Car Stereo Service Bulletin

Model: XR-U220/U330

No. 294

Subject: Improving Clock Accuracy

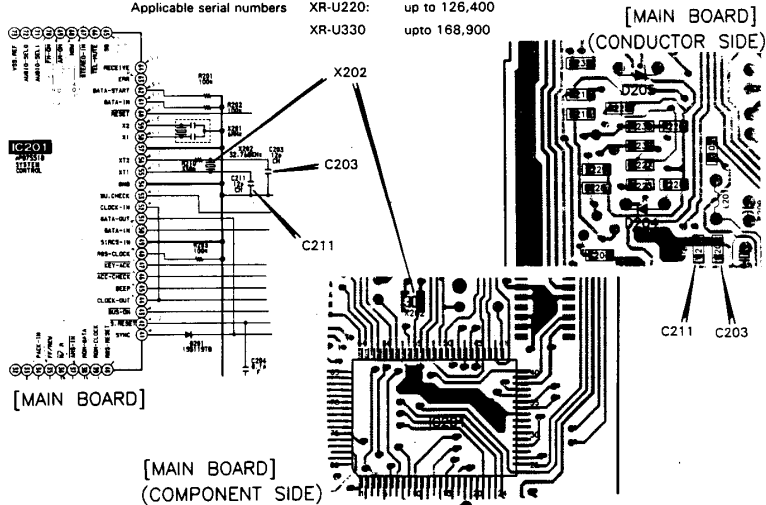
(13) The accuracy of the clock may be poor.

Solution: Replace X202, C203, and C211 on the Main board as shown below.

REF	FORMER		NEW	
	DESCRIPTION	PART NUMBER	DESCRIPTION	PART NUMBER
X202	VIBRATOR, CRYSTAL (32.768KHZ)	1-579-532-11	VIBATOR, CRYSTAL (32.768KHZ)	1-579-709-11
C203/ C211	CAPACITOR, CERAMIC CHIP (12PF)	1-163-229-11	CAPACITOR, CERAMIC CHIP (12PF)	1-163-229-11
